T-HANDLE UP/DOWN BLOCK REINFORCEMENT KIT

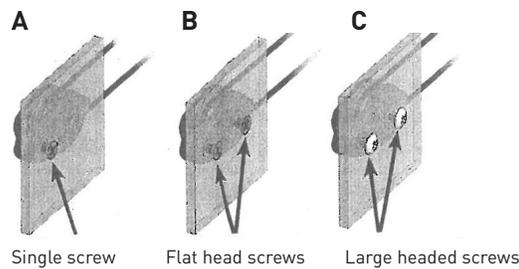
Due to the additional loads on the up/down control system with the rudder mounted eVolve™, we recommend inspecting the screws attaching the internal block for the up/down system. The blocks are located inside of your kayak in front of your seated position. Look for the exposed screw heads near the cockpit area, or reach inside and follow the lines to the point where they make a turn. If you have just one screw **(A)** or if flat head screw **(B)** are used, replace the hardware with the screws included in this bag. If you have two large-headed screws **(C)** holding the block in place, no replacement is necessary.

If you only have one screw holding the block **(A)**, an additional hole will need to be drilled to bolt through another location. To drill a new hole, locate the single screw currently holding the block and drill a 3/16" hole 1-1/8" back from the center of the current screw. This will allow the new hole to align with the other bolting location on the block.

Illustration **(D)** shows the new installation with the provided screw and nut.

The longer screw goes through the thicker end of the block.
